**Attachment 1: Responses to NRC RAIs Specific to WCAP-17788, Volume 3
Supporting the Closure of GSI-191 (PA-SEE-1090) and Mark-ups to
WCAP-17788, Volume 3 NON-PROPRIETARY Attachment**

NRC Correspondence, "Request for Additional Information RE: Pressurized Water Reactor Owners Group Topical Report WCAP-17788, 'Comprehensive Analysis and Test Program for GSI-191 Closure,'" August 2016, ADAMS Accession No. ML16102A357.

Figure RAI-3.3-1 - Boil-off Curve for a Westinghouse 4-loop PWR

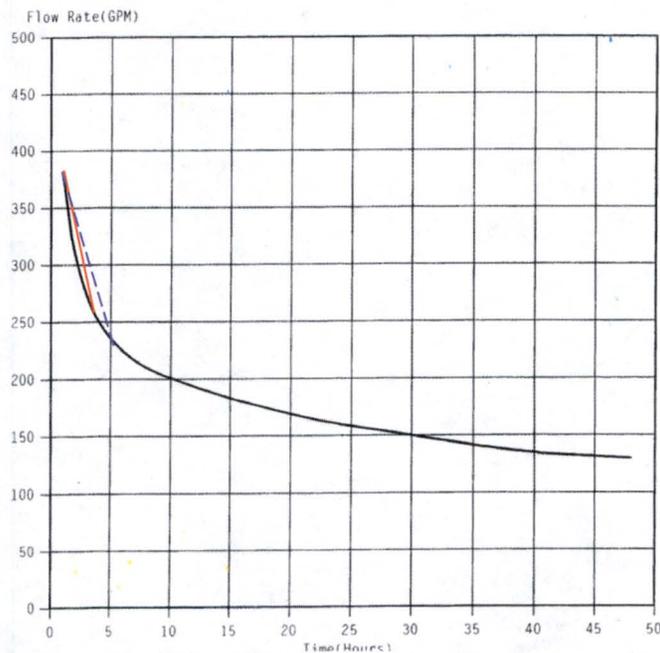
The use of average core boil off values as discussed in Section 5.1 of Volume 3 may result in unrealistic values of fiber at the core inlet. Most of the fiber will penetrate the strainer early in the loss-of-coolant accident (LOCA) response. Using an average value when the actual flow rate decreases during the event can result in unrealistic values of debris transported to the core. Provide justification that the use of an average value results in realistic or conservative values for debris entering the core.

3. Figure RAI-3.3-1 displays a boil-off curve for a typical Westinghouse 4-loop pressurized water reactor.
 - a. The solid black line represents the calculated boil-off rate as a function of time after the accident. The total amount of debris-laden coolant provided to the core is calculated as the integral under the curve between the time that recirculation is initiated and the time of hot-leg switch-over.

- b. The solid red line connects the boil-off rate at the start of recirculation to the sump to boil-off rate at the start of hot-leg switch-over estimated to be at two hours after the event initiation. The total amount of debris laden coolant provided to the core using the Alternate Simplified Method of WCAP-17788, Volume 3, Section 5.0 is calculated by the trapezoidal rule.

- c. Similarly, the blue dashed line connects the boil-off rate at the start of recirculation to the boil-off rate at the start of hot-leg switchover that is estimated to be at five hours after the event initiation. Again, the total amount of debris laden coolant provided to the core using the Alternate Simplified Method of WCAP-17788, Volume 3, Section 5.0 is calculated by the trapezoidal rule

The area under the exponential core boil-off (black) curve is less than the area under either the red solid line or the blue dashed line. This would be the case for all PWRs.

Thus, the use of the average boil-off rates conservatively overestimates the total debris laden coolant provided to the core for the Simplified Alternate Method. Thus, the Simplified Alternate Method provides for a conservatively large amount of debris-laden coolant to the core compared to a computed exponential boil-off curve.

Given the sum of the discussion above, the use of the average core flow rate is taken to be a reasonable approximation employed in the Simplified Alternate Method of Section 5.0 to assess the deposition of fibrous debris at the core inlet for a CLB loss-of-coolant-accident (LOCA).

Figure RAI-3.26-2 Boil-off Curve for a Westinghouse 4-loop PWR

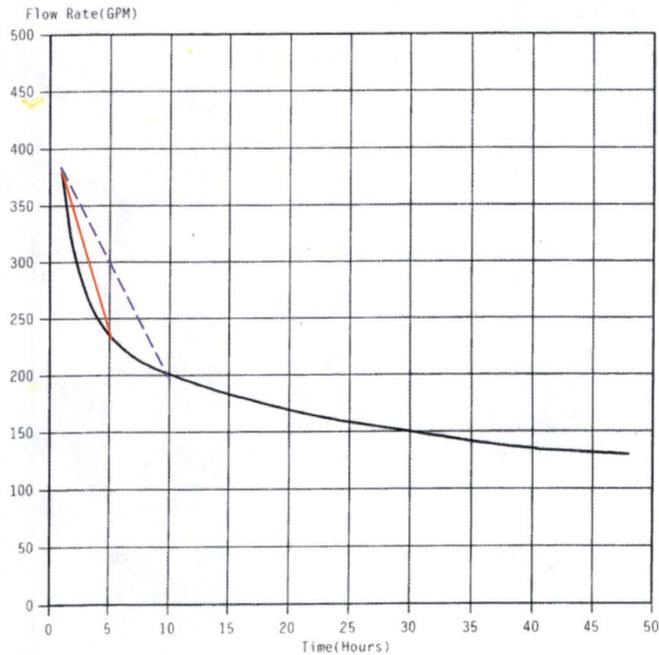
What factors and conditions were considered when determining the inputs for Parameters 11 and 12? The response should support the concept that "a method has been developed to conservatively predict and assess the time-dependent delivery of fibrous debris to the RV and core for a CLB." Confirm that the response also applies when determining the "average core boil-off flow" used in the simplified alternate method described in Section 5.

For example, Figure RAI-3.26-1 contains a boil-off curve for a typical Westinghouse 4-loop pressurized water reactor. The solid black line represents the calculated boil-off rate as a function of time after the accident. The solid red line connects the boil-off rate at the start of recirculation from the sump to boil-off at the start of hot-leg switch-over estimated to be at 5 hours after the event initiation. The total amount of debris-laden coolant provided to the core is calculated as the integral under the curve. Clearly, the area under the core boil-off curve is less than the area under the red curve. Furthermore, the greater the time span between start of recirculation from the sump to the start of hot-leg recirculation, the greater the conservatism in coolant mass evaluated using the Simplified Alternate Method (see the blue dashed line). Thus, the Simplified Alternate Method provides for a conservatively large amount of debris-laden coolant to the core compared to the computed boil-off curves.

Again, no attempt was made to determine the magnitude of the conservatism associated with the use of the average of the boil-off rate at the start of recirculation and the boil-off rate at the start of hot-leg switch-over. Rather, it was recognized that the use of this value provided additional conservatism to the overall method.

Figure RAI-3.32-1 Reactor Vessel Fibrous Debris Collection as a Function of Time Step Selection

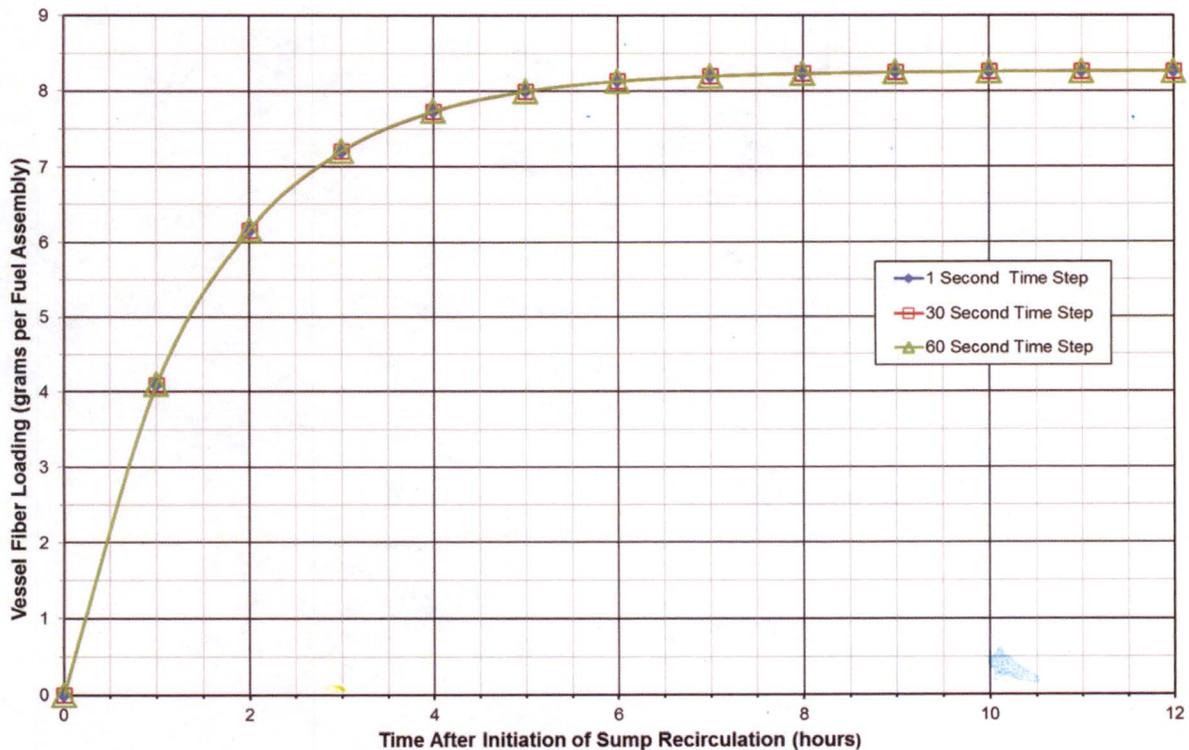
- a. Provide results for an example case analyzed with the CLB method to illustrate the effect of the time step size. Provide the results from two calculations performed with time step sizes of 1 second and 10 seconds and compare the results from the calculation using the recommended time step size of 60 seconds.

The calculations were run for 12 hours of problem time after initiation of recirculation from the reactor containment building sump. The results of the sensitivity calculations are shown in Figure RAI-3.32-1. Time $t=0$ of the plot is to be taken as the start of recirculation; 25 minutes after initiation of the LOCA. A green line with green triangles as markers represents the results using a 60 second time step, a red line with red squares as markers represents the results of the 30 second time step, and a light blue line with solid diamonds as markers represents the results of the 1 second time step (see the legend on the right-hand side of Figure RAI-3.32-1). The difference between the results of the three time step durations are sufficiently small that they overlay one another on the plot of Figure RAI-3.32-1 and are indiscernible.

From the plot of Figure RAI-3.32-1, it is concluded that following initiation of recirculation from the reactor containment building sump (time = 0), there is negligible difference between the three sets of results using three different time steps.
